ADDENDUM NO. 2
TO RFP #2024-04
KEYS ROAD RESERVOIR PROJECT
DATE ISSUED: June 28, 2024

SUBJECT: CLARIFICATIONS AND CHANGES TO THE PLANS AND SPECIFICATIONS

DEMOLITION PLAN

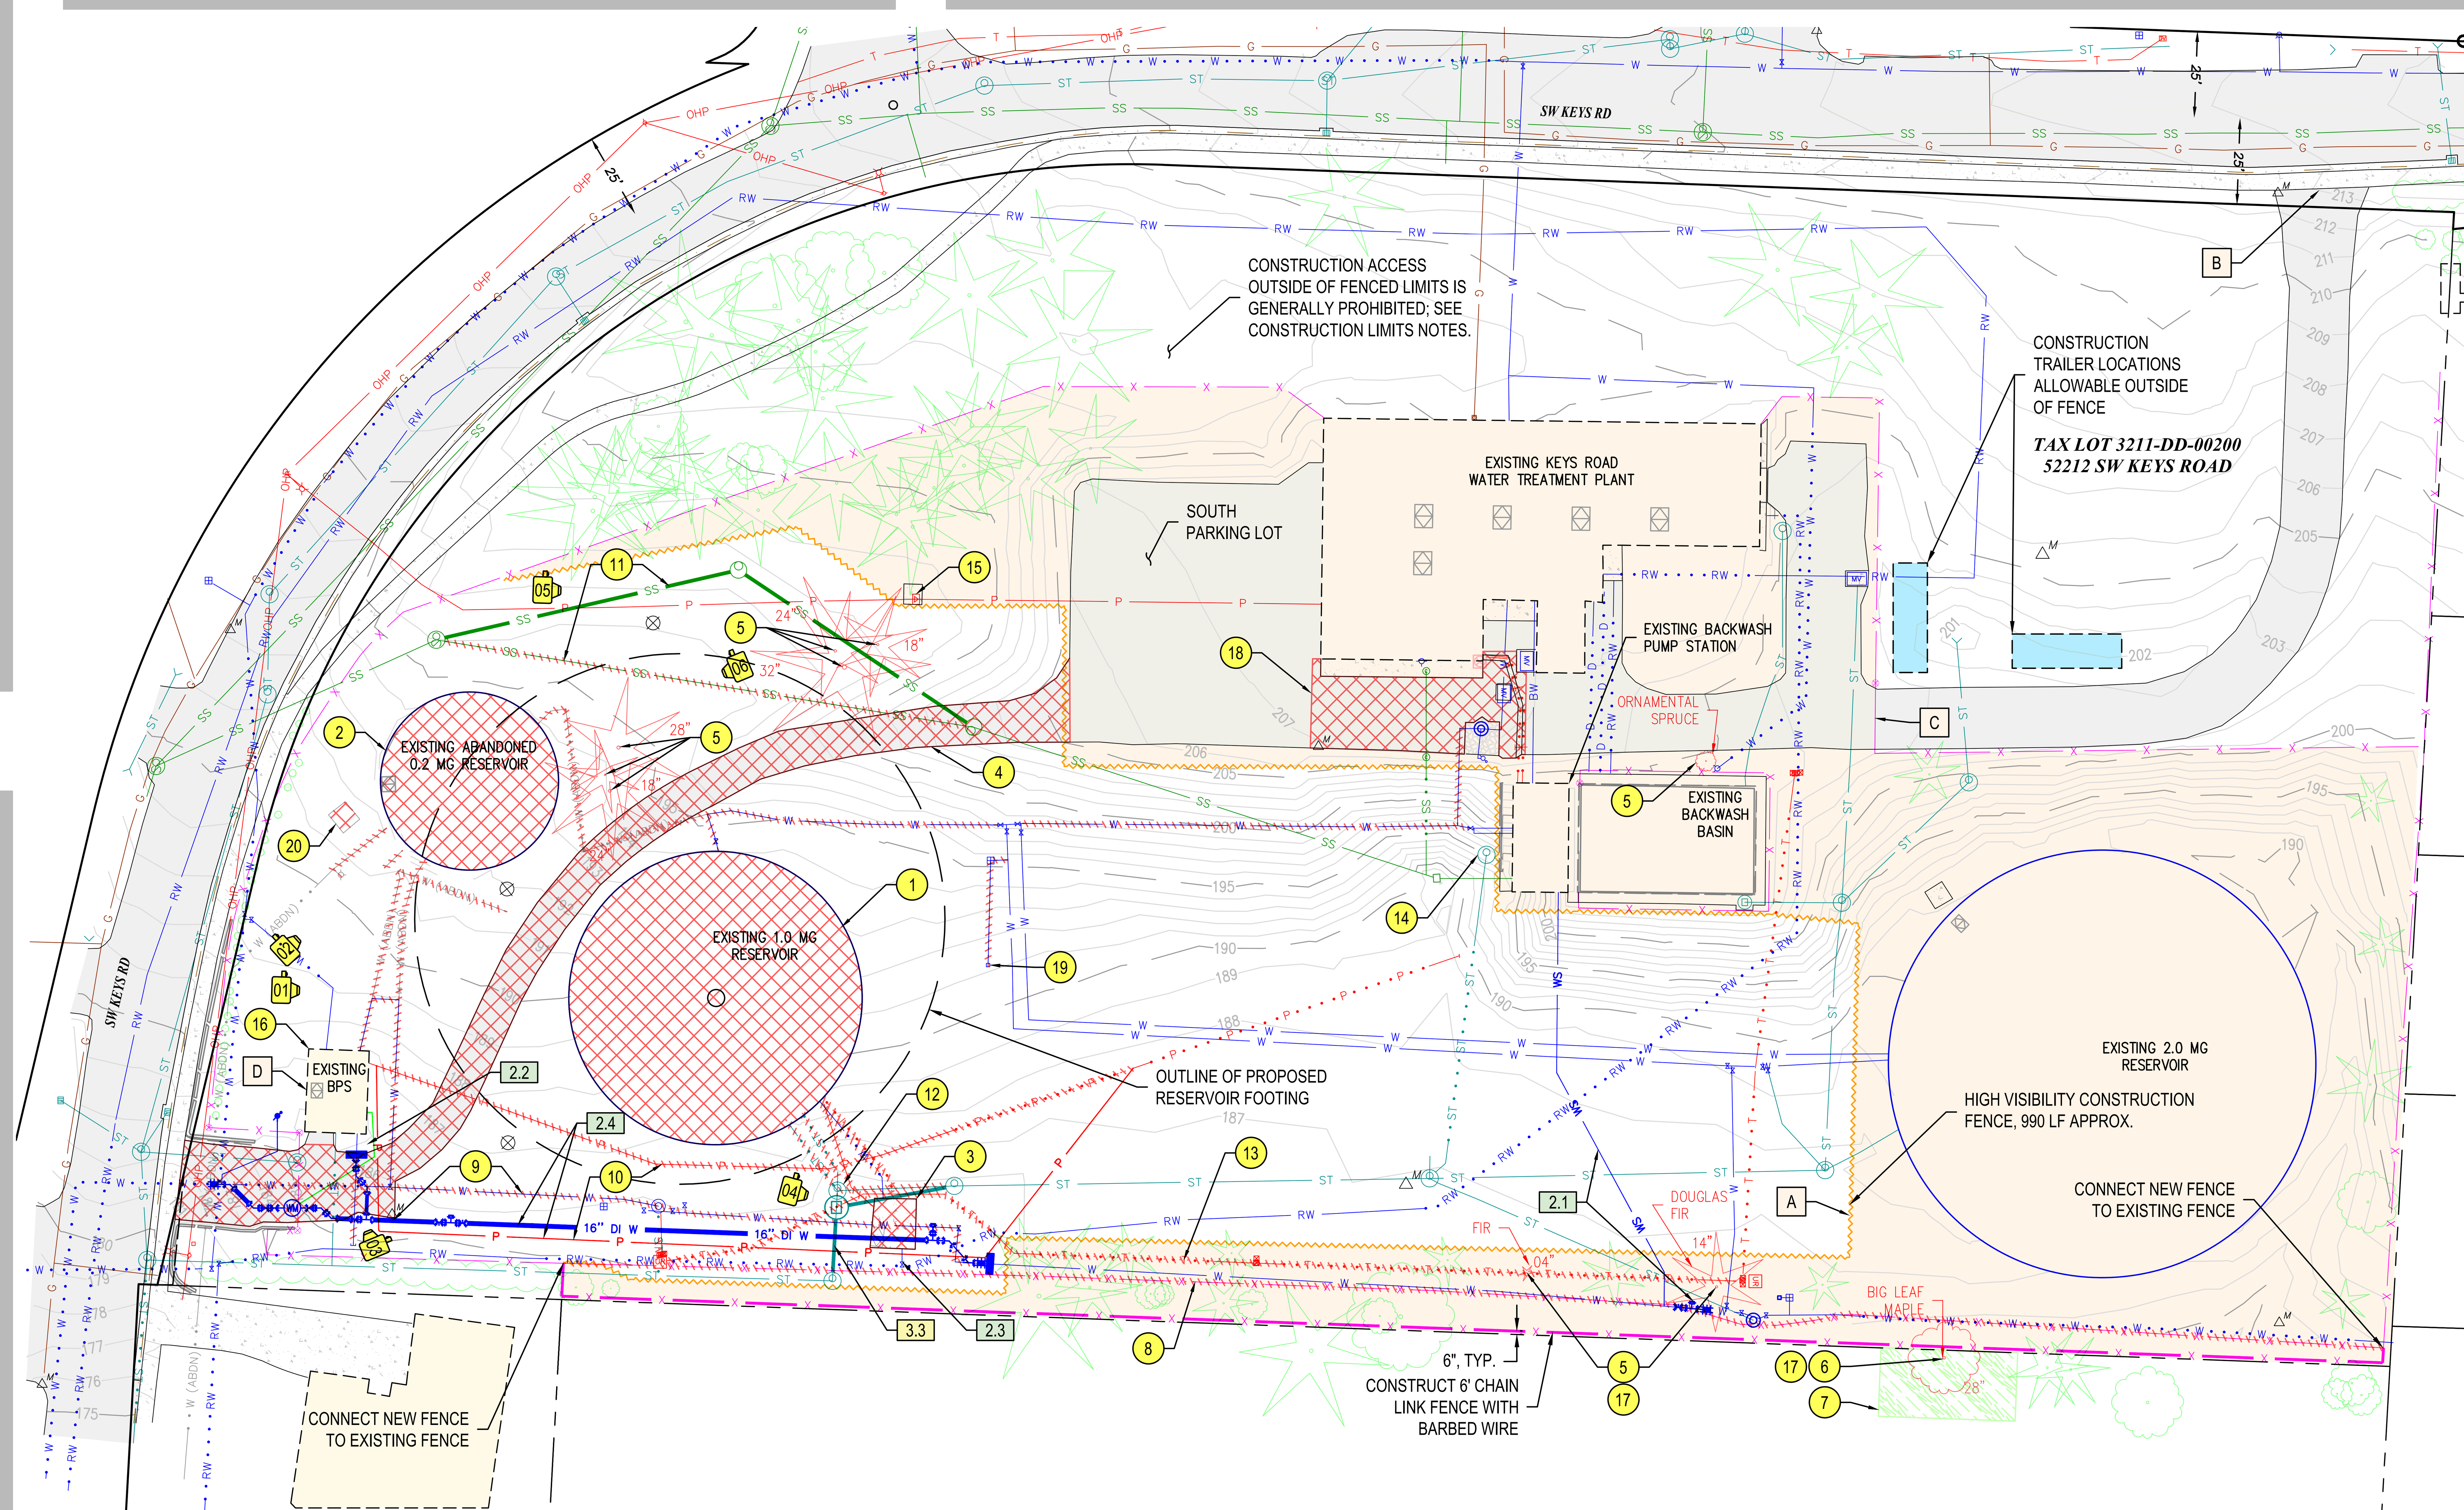
> **Answer**: A new sample station is required. See revised note 27 in the updated Dwg No. C15 included with this addendum. Also see the revised Dwg C04 included with this addendum.

b. **Dwg No. C04 is replaced in its entirety with the attached updated Dwg No. C04.**
c. **Dwg No. C06 is replaced in its entirety with the attached updated Dwg No. C06.**
d. **Dwg No. C15 is replaced in its entirety with the attached updated Dwg No. C15.**
e. **Dwg No. C21, Detail 6:**
CURRENTLY SHOWS:
A valve on the branch of the tee.
IS REVISED AS:
No valve should be included on the branch of the tee.

RESERVOIR SUBGRAGE DETAIL 201/C12

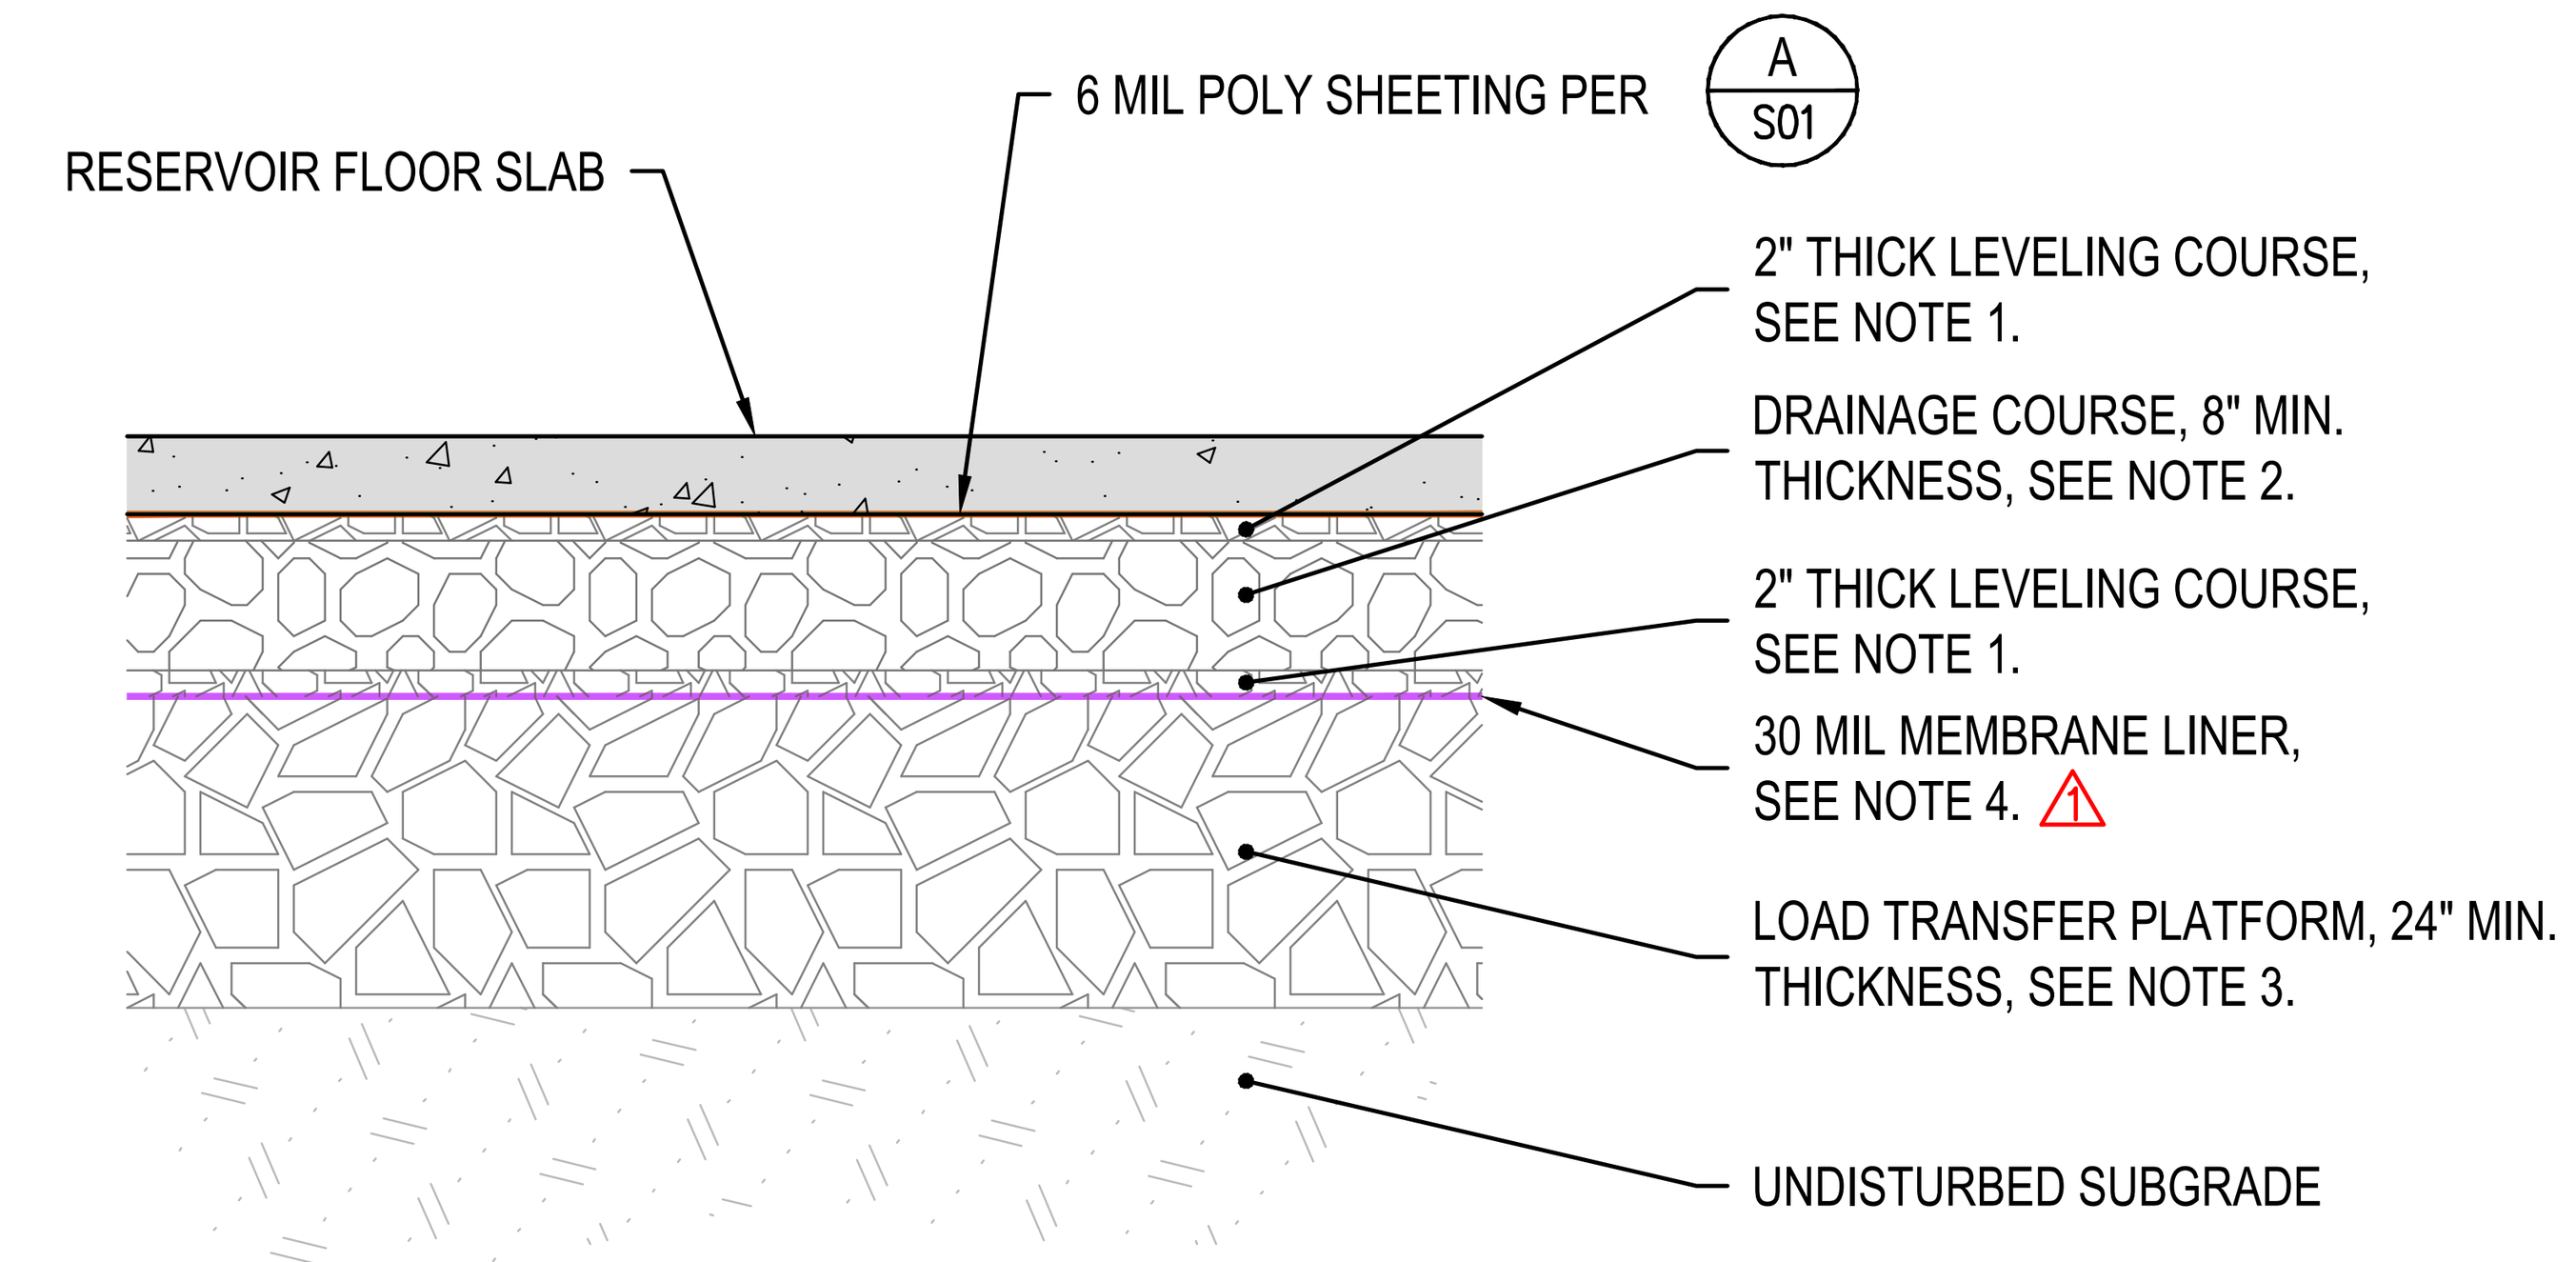
q. **Question**: Is a layer or two of geotextile required to protect the 30 mil liner?

> **Answer**: Refer to revised Dwg No. C23 included with this addendum for additional liner, geotextile, and leveling course information.

3) LOAD TRANSFER PLATFORM SHALL BE IMPORTED CRUSHED ROCK COMPACTED TO 95% OF MDD IN ACCORDANCE WITH ASTM D1557.
4) 30 MIL LINER SHALL BE A LINEAR LOW DENSITY POLYETHYLENE (LLDPE) LINER WITH WATERPROOF SEAMS AS REQUIRED TO PROVIDE A CONTINUOUS DRAINAGE BARRIER UNDER THE RESERVOIR FOOTPRINT. PROTECT LINER FROM AGGREGATE WITH A LAYER OF TENCATE MIRAFI 1100N GEOTEXTILE (OR EQUAL) DIRECTLY BELOW THE LINER.

BURIED SAMPLE TAP DETAIL

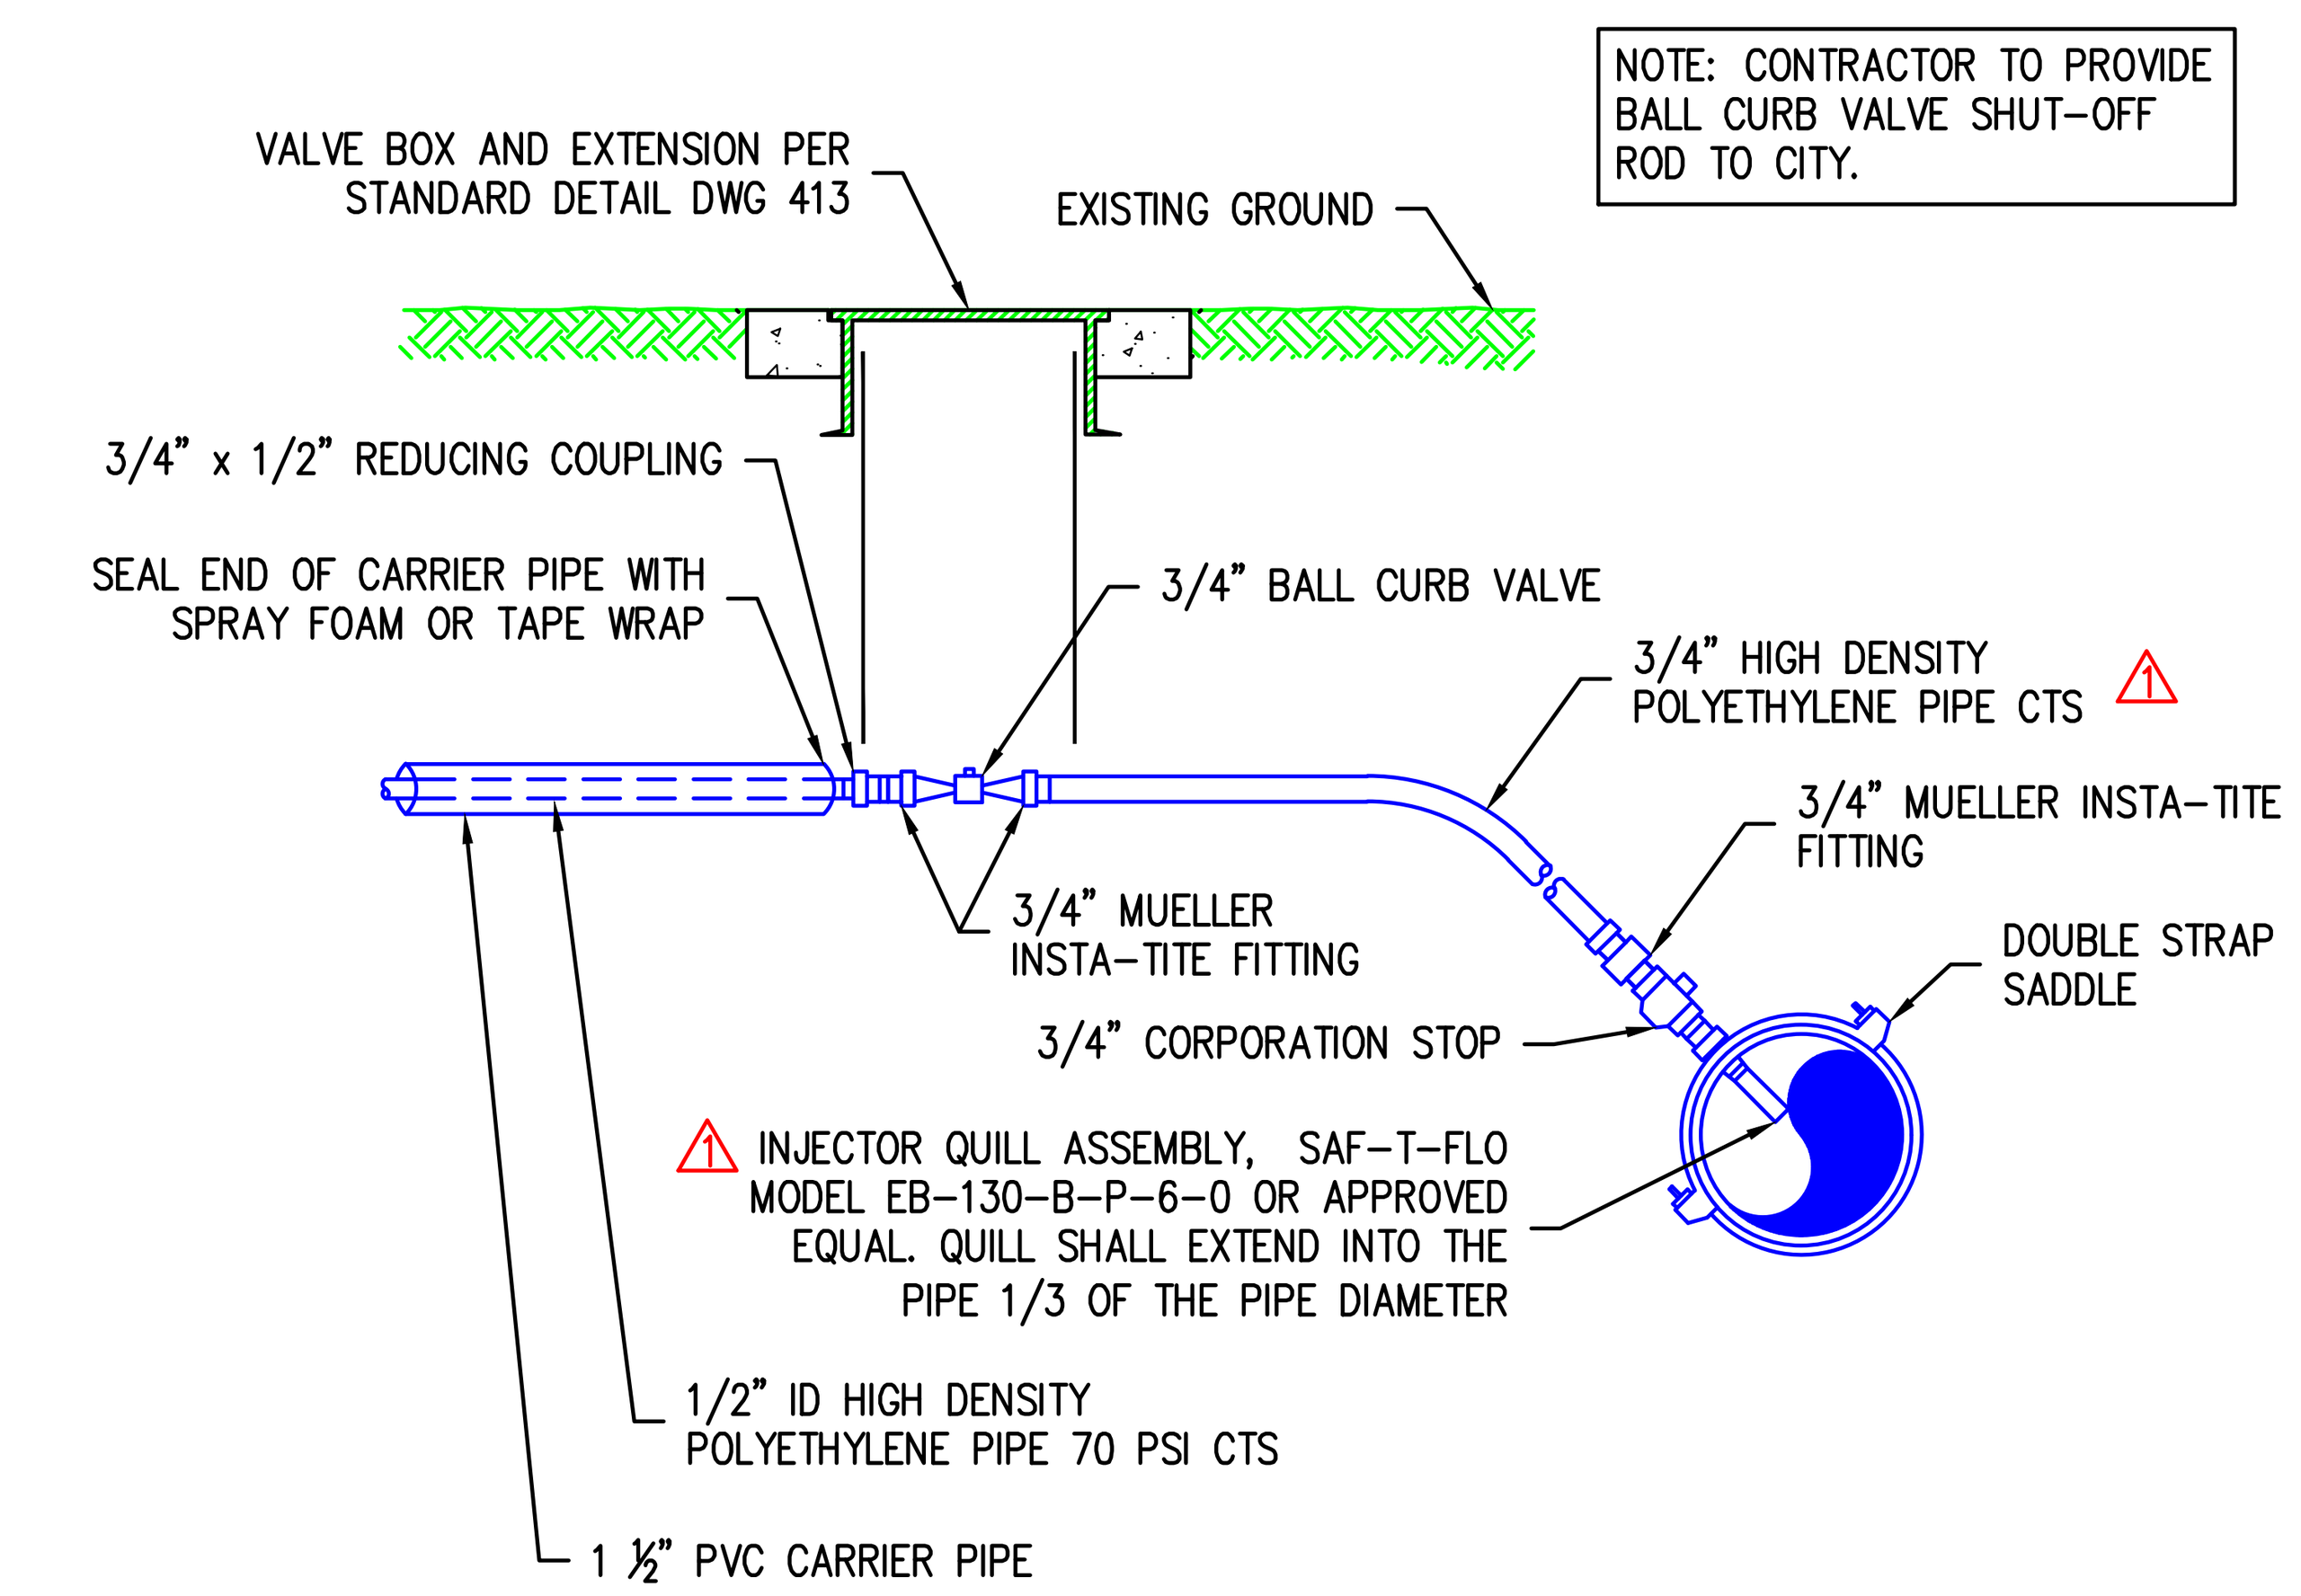
s. **Question**: Detail 217 on sheet C28 is for a buried sample tap and shows an 'injector' extending 1/3 of the way into the pipe. Please provide further information on what is required here.

t. **Question:** Detail 217 on sheet C28 also calls out ½" IPS size HDPE service poly after the curb valve. I am not aware that this size is made. As far as I know, IPS size service poly only goes down to ¾" and only CTS service poly is available in ½" size.

> **Answer**: Refer to revised Dwg No. C28 included with this addendum for product information.

> **Answer**: Refer to revised Dwg No. C28 included with this addendum for updated HDPE pipe requirements.
